STAFF MEMORANDUM TO BOARD OF ZONING APPEALS

Address:	514 Spring St SE	Parcel No.:	0384 22 D
Public Meeting Date:	7/17/2024	Case Number:	PF-1389422-BZA
Owner(s):	Sean & Lindsey Finn	Applicant:	Sean & Lindsey Finn
Existing Zoning:	RS-10	Existing Land Use:	Low Density Residential

STAFF MEMORANDUM TO BOARD OF ZONING APPEALS Variance – 514 Spring Street SE July 17, 2024

Figure 2 – Colored exhibit of proposed pool location

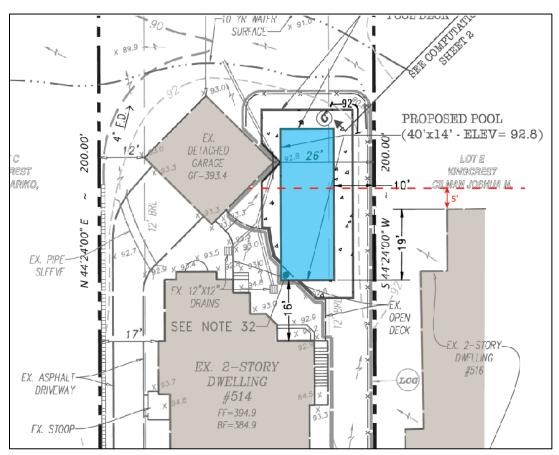
As shown in Figure 2 below, the front edge of the proposed pool would start 19 feet from the rear towards the front of the neighboring house located at 516 Spring Street SE. The pool meets the setback requirement from the neighboring property's rear wall at 510 Spring Street SE.

- O Variance Required The proposed pool requires a variance from this requirement. The proposed pool is adjacent to the neighboring principal structure for a length of 19 feet. With the setback requirement of 5 feet from the extension of the rear wall, the variance required is for a total of 24 feet.
